Section 42A Report to the Hearings Committee

Proposed Plan Variation 2

Hill Country Landscape Domain Boundary Review

November 2014

6.3.1 Amend Planning Map 39 to retain the existing Hill Country Landscape Domain boundary in relation to Lot 4 DP 80215

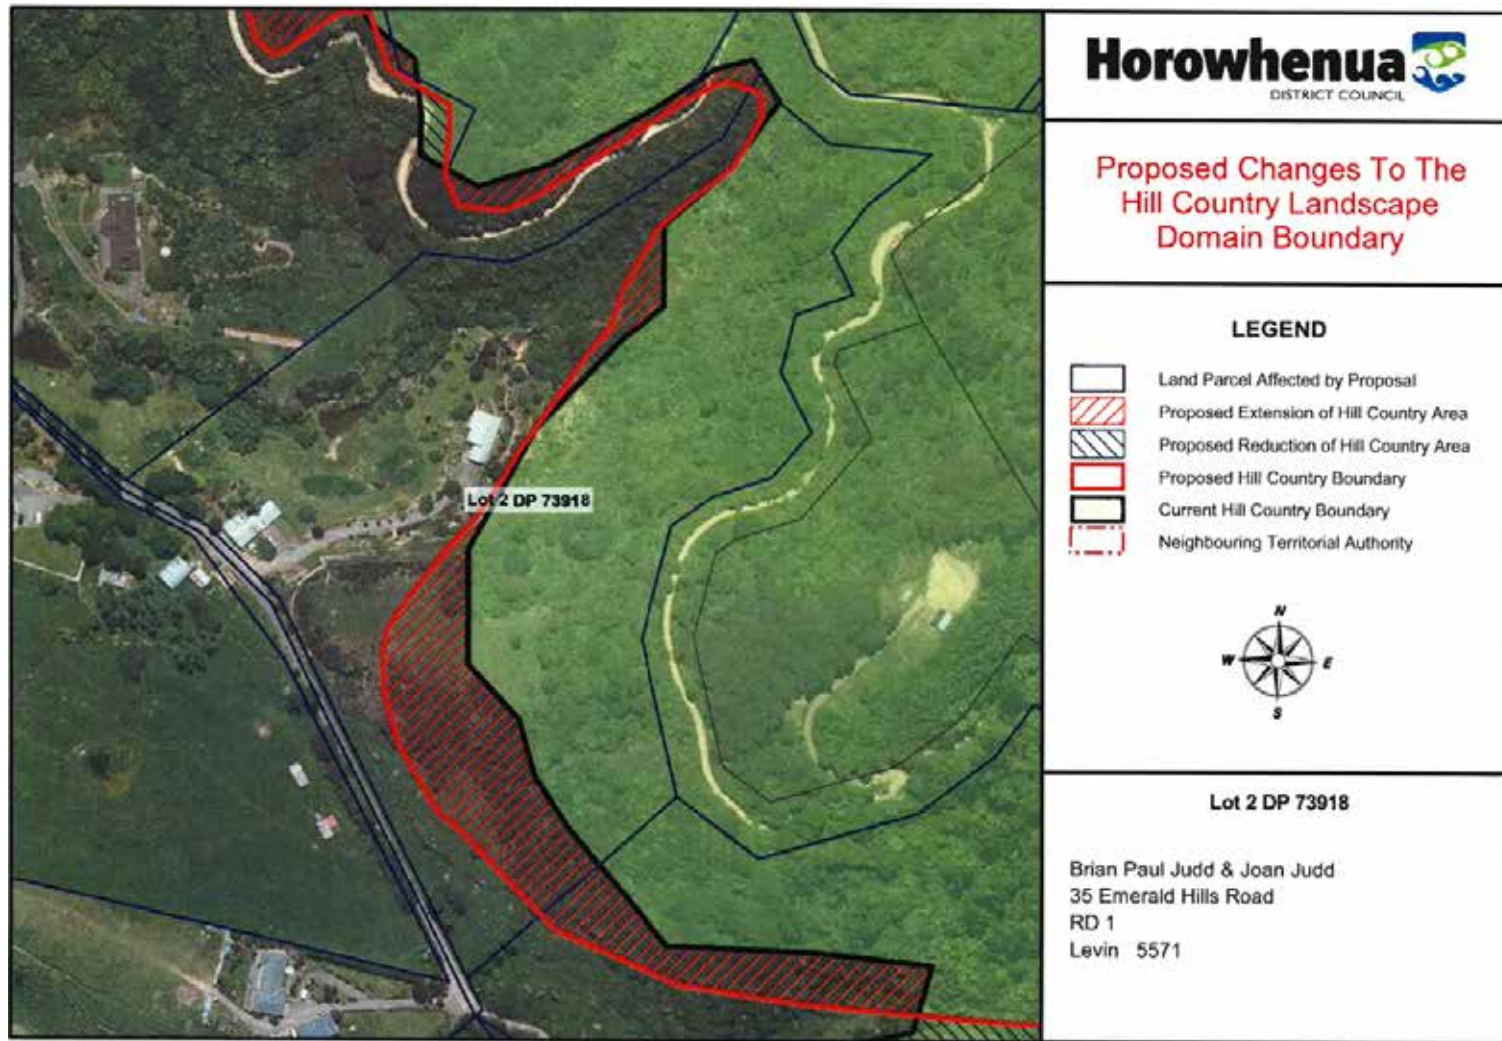
1. M. J. Page (201.00) opposes the proposed change to the western boundary of the Hill Country Landscape Domain Boundary in relation to his property which is legally described as Lot 4 DP 80215. He seeks that the boundary be retained in its current location as shown in the map provided with his submission.

2. The current position of the western boundary of the Hill Country Landscape Domain in relation to Lot 4 DP 80215 was considered by Council Officers as the most appropriate position for the boundary during the appeal between Range View Ltd and M. J. Page v Horowhenua District Council on Plan Change 20. The southern portion of Lot 4 DP 80215, which is the subject of M. J. Page's submission, is lower-lying than the northern portion of the property and as a result of the appeal it was considered that this portion of the property was more closely aligned with the characteristics of the Tararua Terrace Landscape Domain.

3. It was Officers intentions to retain the current boundary of the Hill Country Landscape Domain in relation to Lot 4 DP 80215 and not change it as part of PPV2. However due to a historical anomaly with the Planning Maps the most up-to-date map was not referenced when establishing the Hill Country Landscape Domain boundary in relation to this property in PPV2. Therefore it is recommended this submission point from M. J. Page is accepted.

Amend Proposed Planning Maps 39 so that the current position of the western boundary of the Hill Country Landscape Domain is retained in relation to Lot 4 DP 80215 as shown in the map in Appendix 3 (Section 6.3.1).

6.3.2 Amend Planning Maps 38 and 39 in relation to Lot 2 DP 73918

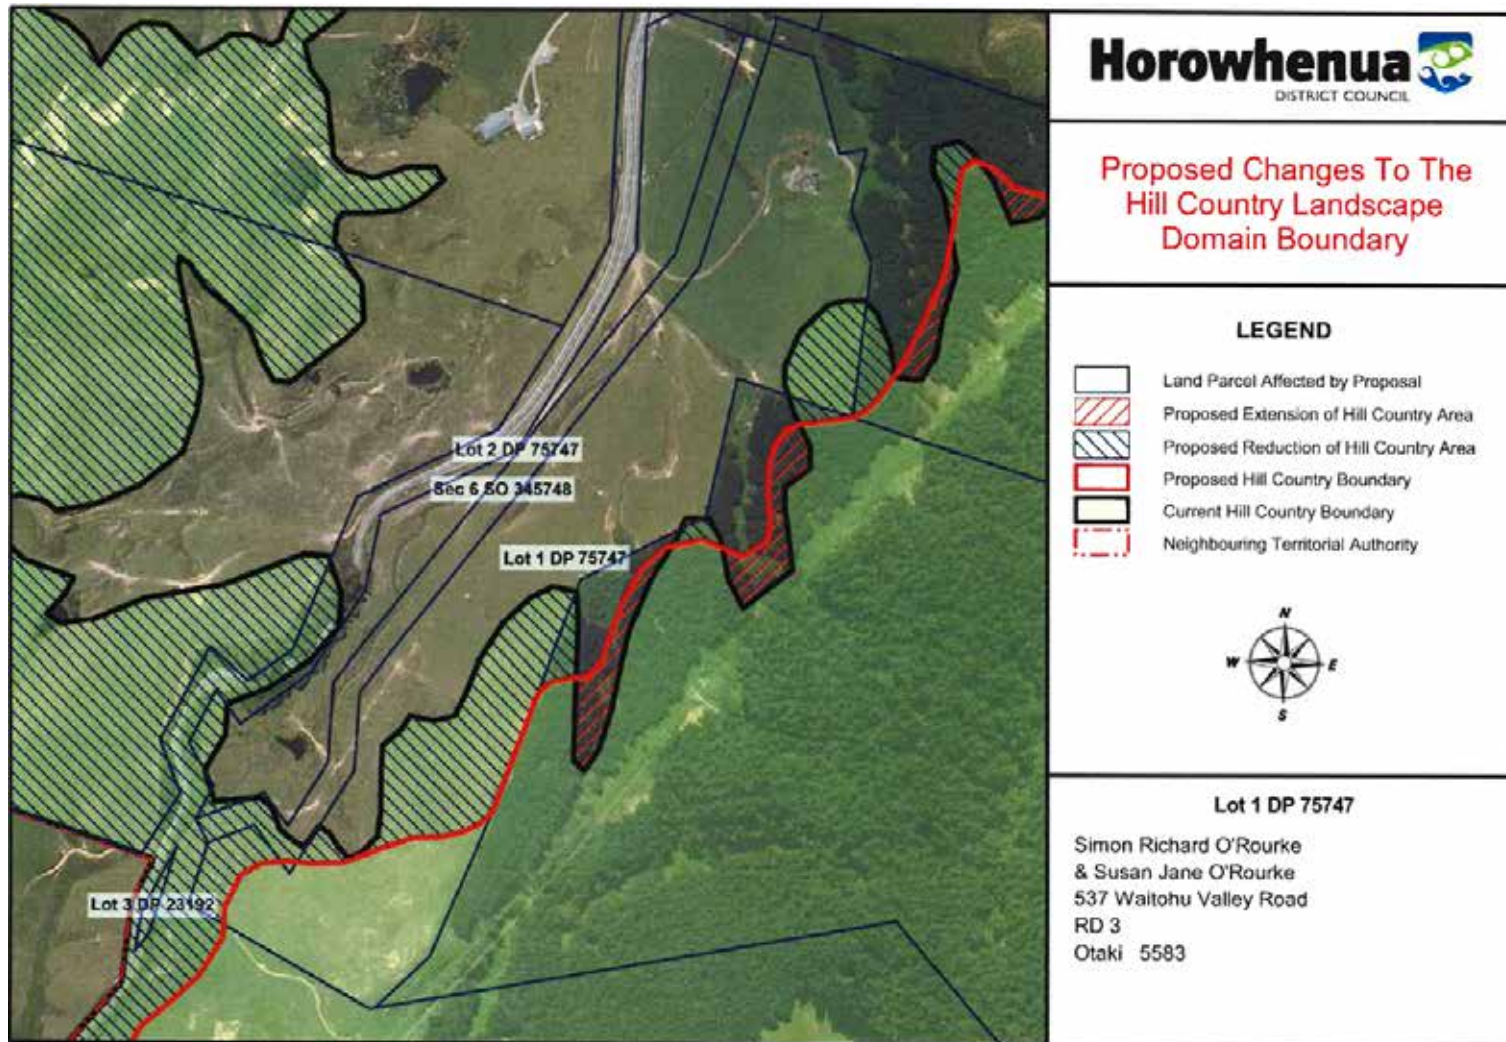
1. Joan and Brian Judd (204.01 and 204.03) oppose the proposed changes to the western boundary of the Hill Country Landscape Domain in relation to Lot 2 DP 73918 (35 Emerald Hills Road). The submitters consider that the Proposed Plan Variation does not accurately identify exactly where the boundary sits in relation to their property. The submitters believe that the Council has provided insufficient and incomplete information to enable them to make a fully informed decision. They consider the consultation that was undertaken as part of this Proposed Plan Variation was also insufficient.

6. Joan and Brian Judd (204.02) seek the retention of the current boundary of the Hill Country Landscape Domain boundary in relation to Lot 2 DP 73918 as in their view the proposed changes to the boundary defeats the purpose of the Proposed Plan Variation.

8. A key area of concern for the submitters appears to be the portion of the proposed Hill Country Landscape Domain boundary that is adjacent to their dwelling. Boyden Evans (Landscape Architect of Boffa Miskell Ltd) and I visited the submitter's property and we noted the portion of the hill where the dwelling has been constructed has been modified to allow for the dwelling and access to the dwelling. As such it is considered to be appropriate to amend the boundary and move it further up the hill slope in the vicinity of the dwelling and driveway so that these areas are avoided and so that it is more closely aligns with the current Landscape Domain boundary.

6.3.3 Amend Planning Map 39 in relation to Lot 1 DP 75747 and subsequently Pt Lot 6 DP 13993 and Pt Lot 1 DP 13837

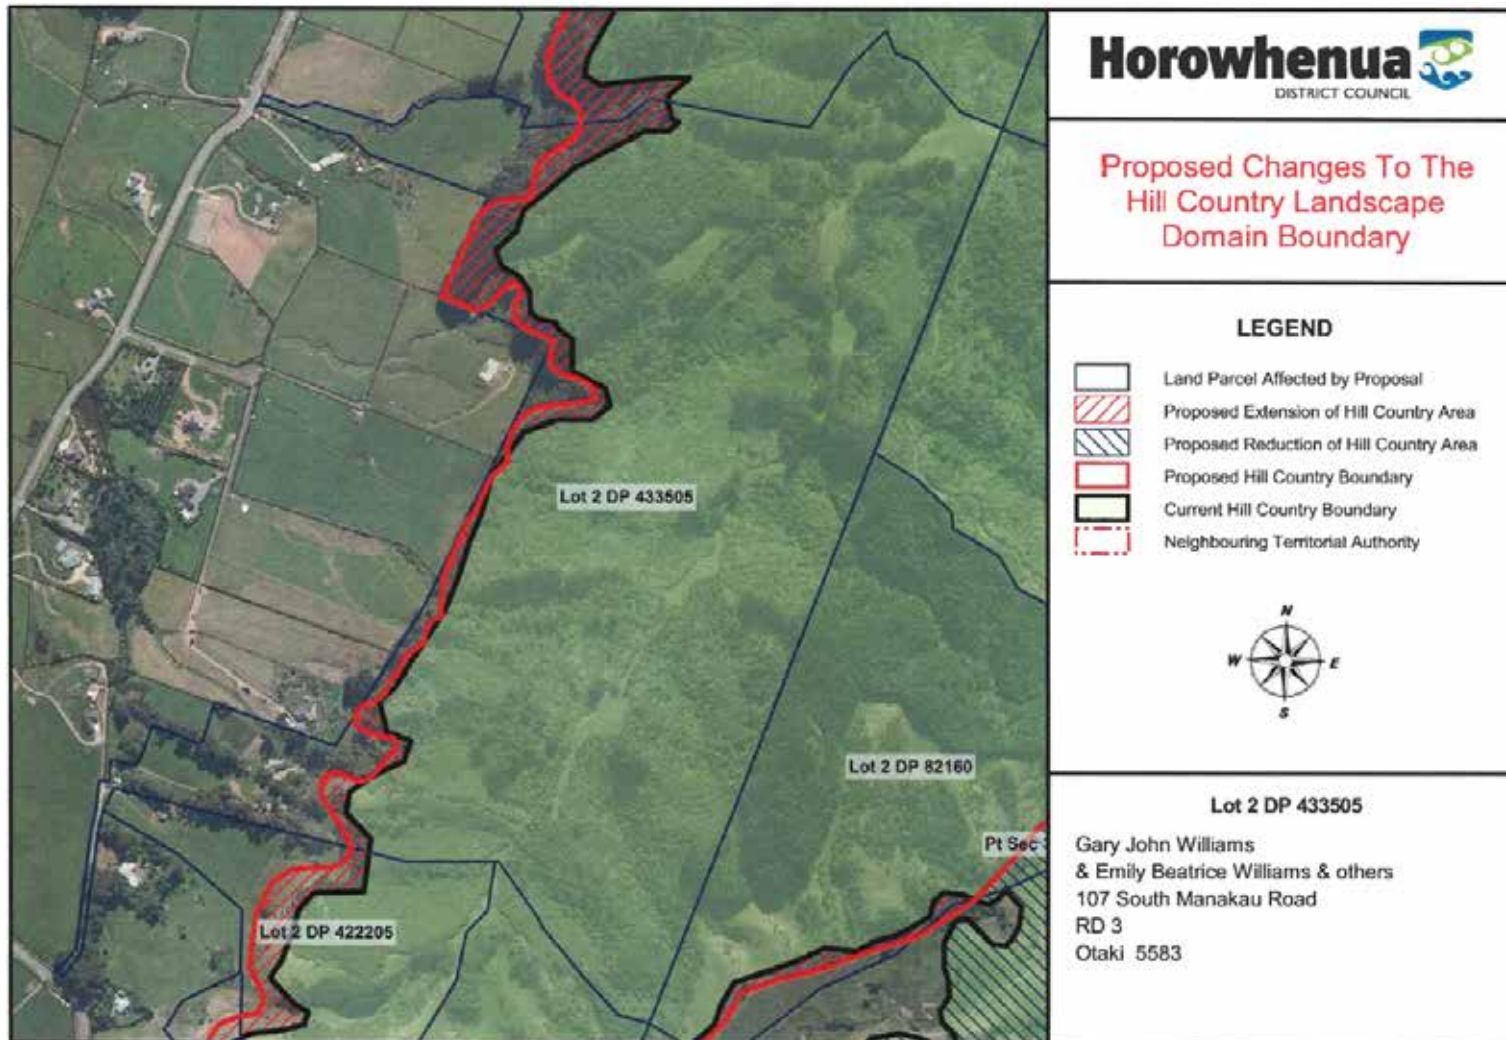
1. Horowhenua District Council, Planning Team (205.00) opposes the proposed changes to the western boundary of the Hill Country Landscape Domain in relation to Lot 1 DP 75747 and subsequently Pt Lot 6 DP 13993 and Pt Lot 1 DP 13837. The submitter considers that a portion of Lot 1 DP 75747 that is proposed to remain within the Hill Country Landscape Domain would better align with the characteristics of the Manakau Downlands Landscape Domain.
2. The submitter seeks that Planning Maps 39 are amended so that the south-eastern corner of Lot 1 DP 75747 remains in the Hill Country Landscape Domain and the rest of the property is

within the Manakau Downlands Landscape Domain. The proposed change would result in very minor changes to the Hill Country Landscape Domain boundary for two of the properties that adjoin this site (as shown on the map provided with the submission).

3. I consider that the area of land on Lot 1 DP 75747 requested to be removed from the Hill Country Landscape Domain and to become part of the Manakau Downlands Landscape Domain, is more consistent with the Manakau Downlands Landscape Domain. This area of land is at the base of hills where the land is not steep in topography and as such it is considered to be most appropriate that Planning Map 39 be amend and that this portion of land becomes part of the Manakau Downlands Landscape Domain. The proposed amendment is supported by Boyden Evans, Landscape Architect of Boffa Miskell Ltd. Therefore it is recommended that this submission point be accepted.

That Planning Map 39 be amended so that the proposed western boundary of the Hill Country Landscape Domain in relation to Lot 1 DP 75747 as well as Pt Lot 6 DP 13993 and Pt lot 1 DP 13837 is in accordance with the map provided with the Horowhenua District Council, Planning Team's submission as shown in the map in Appendix 3 (Section 6.3.3).

6.3.4 Amend Planning Map 39 in relation to Lot 2 DP 433505

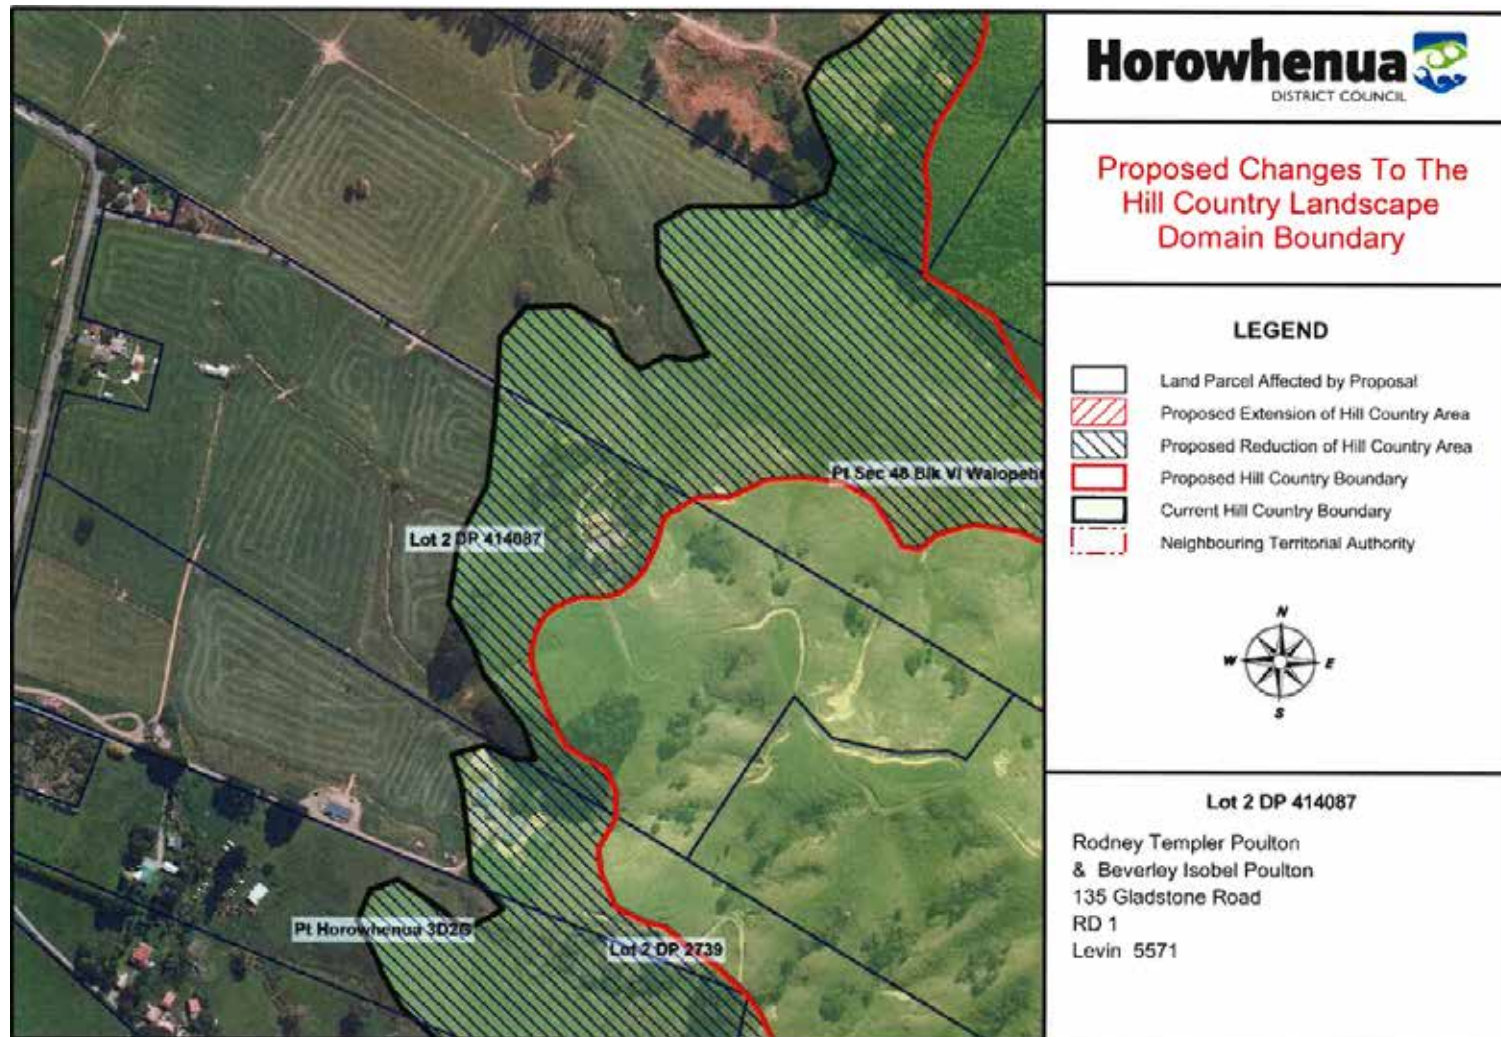
One submission point was received from Gary and Emily Williams opposing the proposed changes to Planning Map 39 in relation to Lot 2 DP 433505 (107 South Manakau Road).

3. It is noted that the amended Hill Country Landscape Domain boundary for this property has been extended beyond the existing boundary (which follows the 100m contour line). In their submission, the landowners maintained that the amended boundary did not accurately reflect the delineation of what would generally be considered as 'hill country'. During our site visit the submitters indicated where they believed the Hill Country Landscape Domain boundary should be, based on their understanding of their property as well as the purpose of the Proposed Plan Variation.
